VIRGINIA ELECTRIC AND POWER COMPANY
RICHMOND, VIRGINIA 23261

VIRGINIA ELECTRIC AND POWER COMPANY
SURRY POWER STATION UNITS 1 AND 2
PROPOSED TECHNICAL SPECIFICATIONS CHANGE
REVISION OF MAIN CONTROL ROOM AND EMERGENCY SWITCHGEAR ROOM
AIR CONDITIONING SYSTEM REQUIREMENTS

Discussion of Change

**Revision of Main Control Room and Emergency Switchgear Room Air
Conditioning System Requirements**

CONTROL ROOM / ESGR CHILLED WATER
SYSTEM OVERVIEW

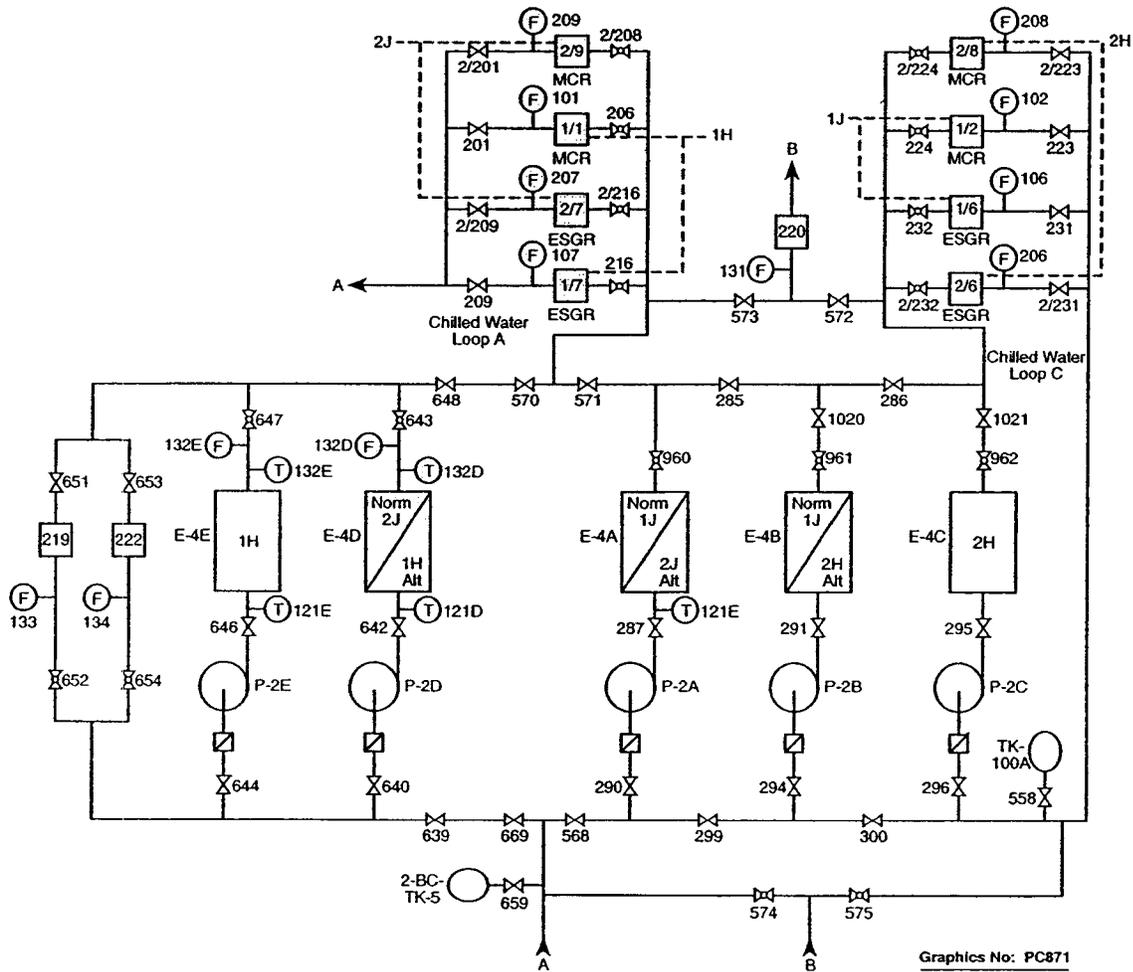
The ACS for the Surry Power Station MCR and ESGRs includes five chillers (1-VS-E-4A, 4B, 4C, 4D, and 4E). Chillers 4A, 4B, and 4C are located in MER-3, in the Unit 2 Emergency Switchgear Room. Chillers 4D and 4E are located in MER-5, in the Unit 2 Turbine Building. The chillers supply chilled water to eight AHUs, arranged in two independent and redundant chilled water loops. Each loop contains four AHUs (one for each MCR and ESGR of each unit), the necessary power supplies, the associated valves, piping (from the supply header to return header), instrumentation, and controls. Two chillers are powered from single emergency buses (1-VS-E-4C from 2H, 1-VS-E-4E from 1H). The remaining three chillers can be powered from either of two emergency buses (1-VS-E-4A from 1J or 2J, 1-VS-E-4B from 1J or 2H, and 1-VS-E-4D from 1H or 2J). The AHUs are powered from the four emergency buses in pairs. Control of the ACS is by manual action. A diagram is included (at the end of Attachment 1) to illustrate the chiller, AHU, and chilled water loop arrangement.
